Item 12.2.1

ORDINARY COUNCIL MEETING

SHIRE OF DARDANUP PROPOSED AMENDMENT TO LOCAL DEVELOPMENT PLAN, LOT 2 BANKSIA ROAD, CROOKED BROOK

RE: Revised draft Local Development Plan (plan: 21/014/002F ; dated: 04/06/2021) — Lot 2 Banksia Road, Crooked Brook

SITE PLAN

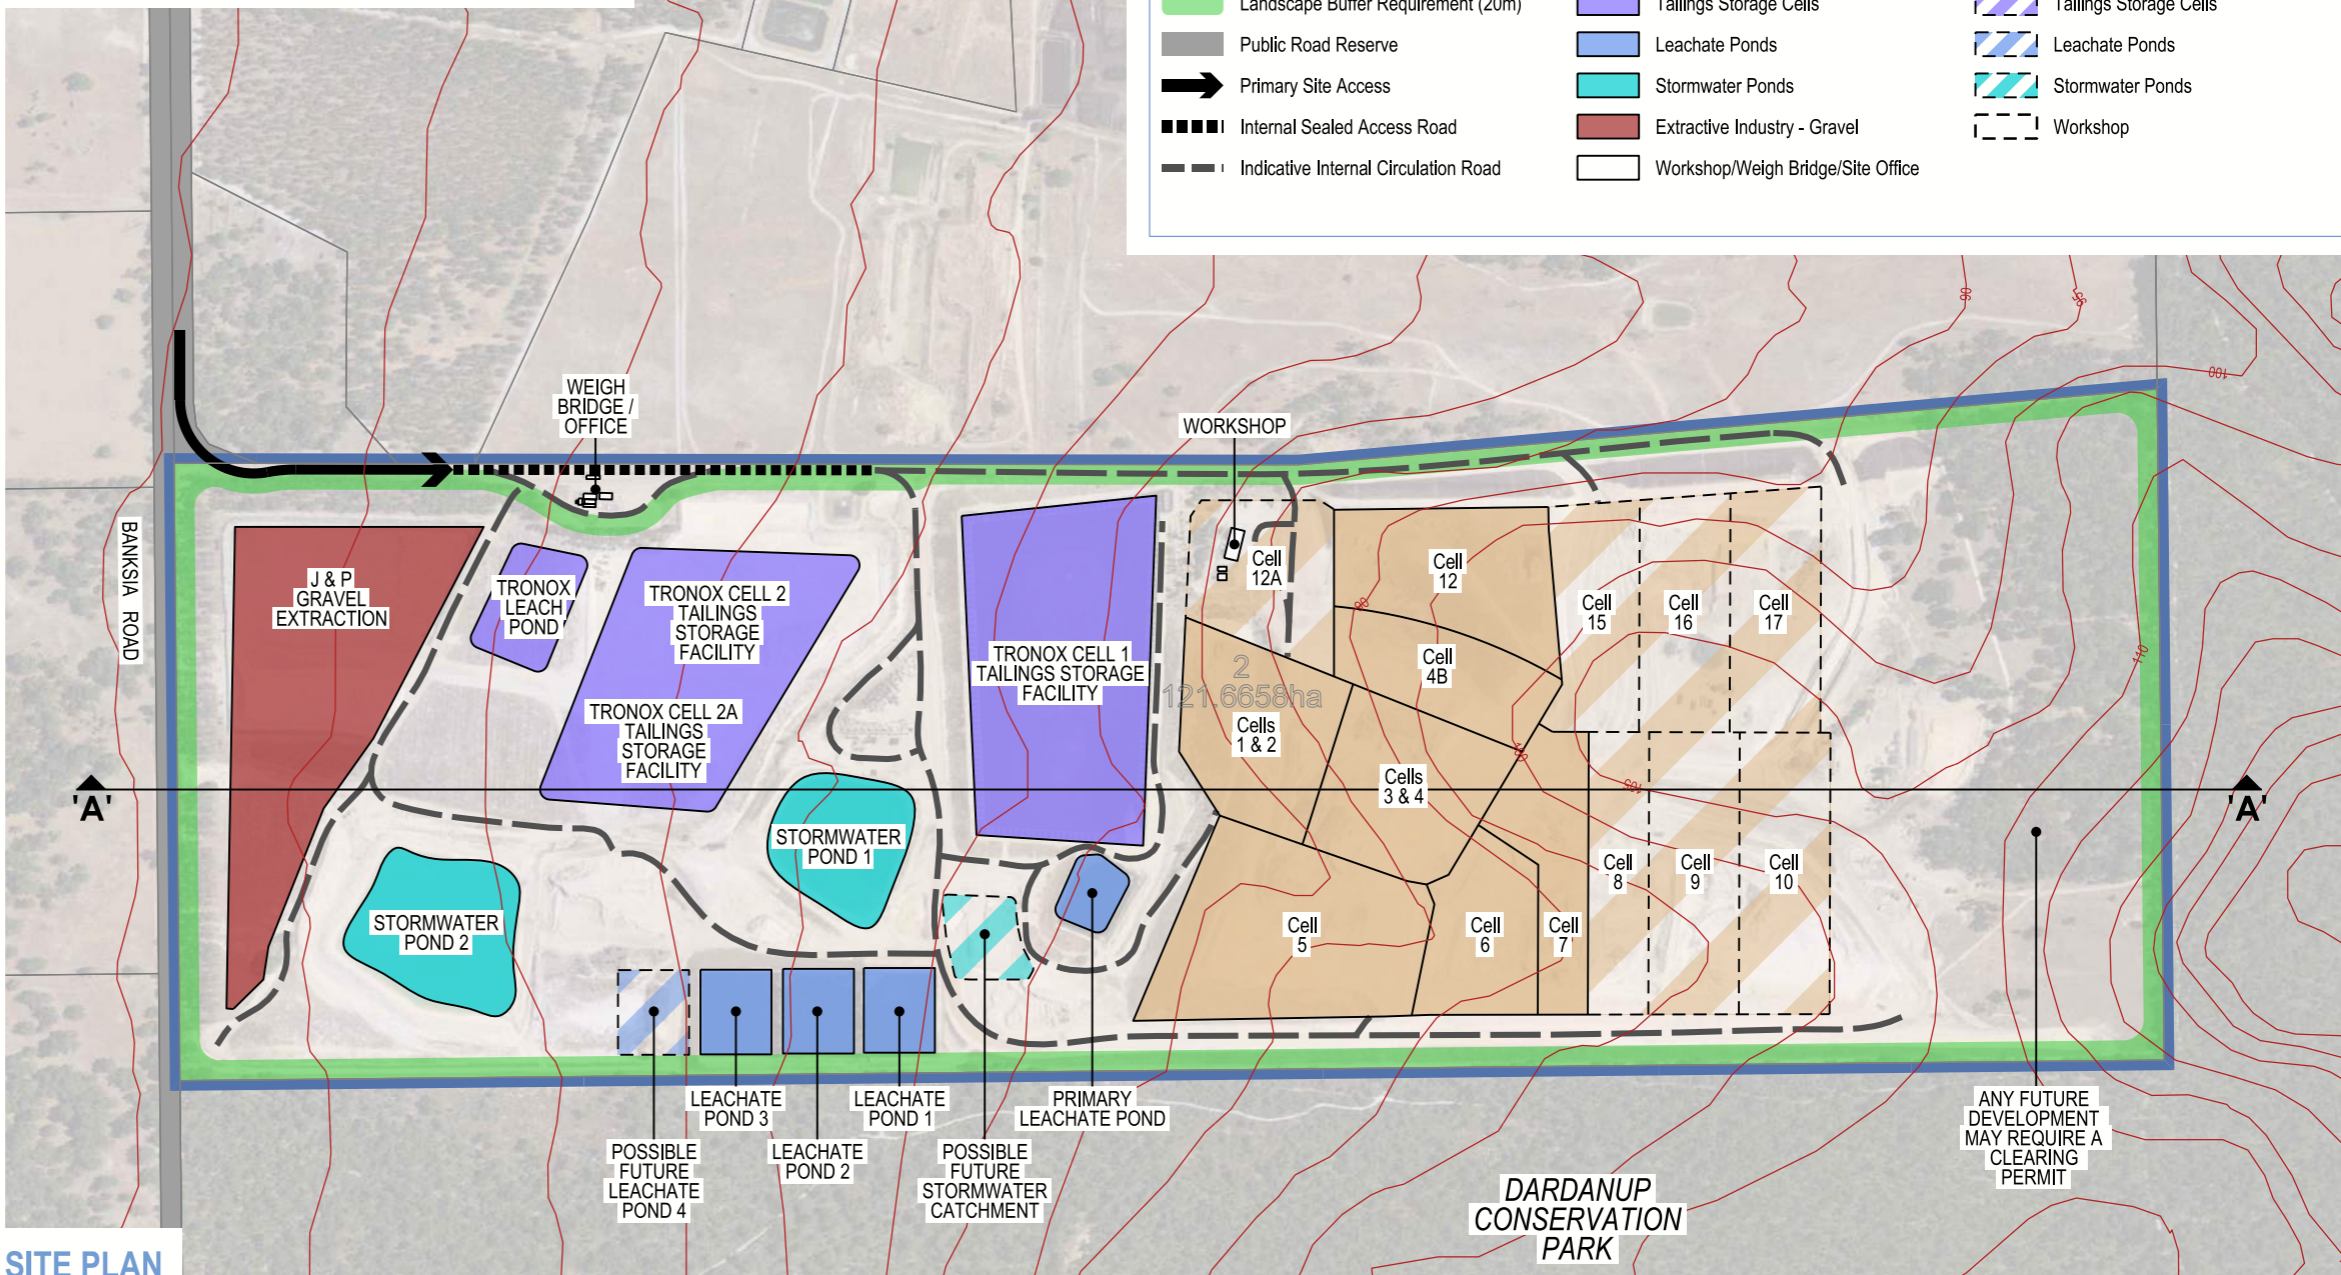
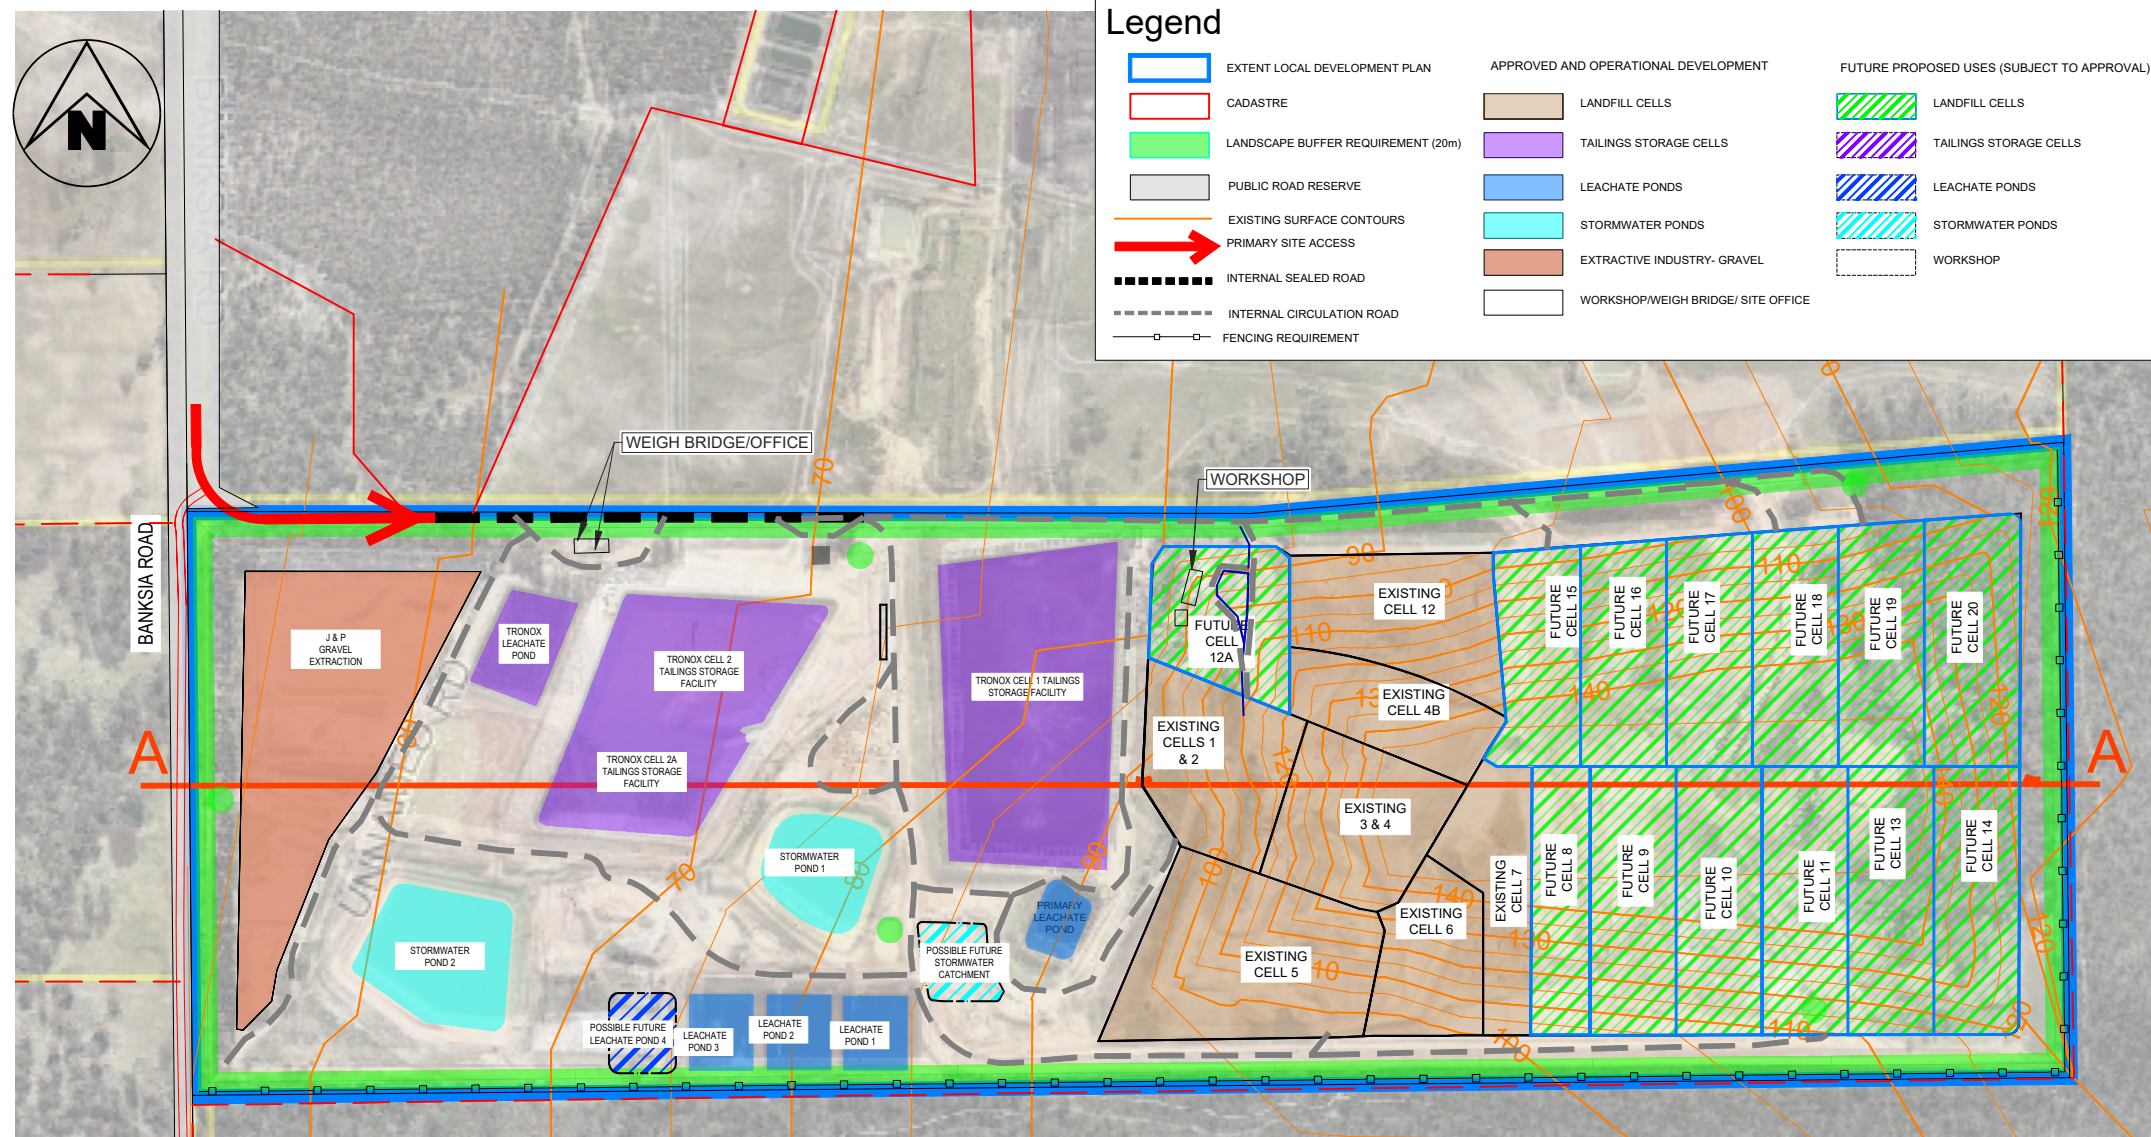
The Department notes that some of its previous comments have been taken into consideration; and Cells 8-10 , 15-17 in the revised draft LDP have been removed (Screenshot 1).

In particular, the following statement has been provided in the revised draft LDP:

- “An Environment Management Plan that addresses vegetation clearing, hydrogeological impacts on surrounding land uses and the investigation and management of contamination or acid sulphate soils”

The Department advises that this statement be revised to encompass the range of issues identified in our previous response, to which the following statement below is recommended instead:

- “An Environment Management Plan that addresses native vegetation clearing, hydrogeological impacts on surrounding land uses, the investigation and management of contamination or acid sulphate soils, a secure water supply, environmental license compliance and a closure plan.”
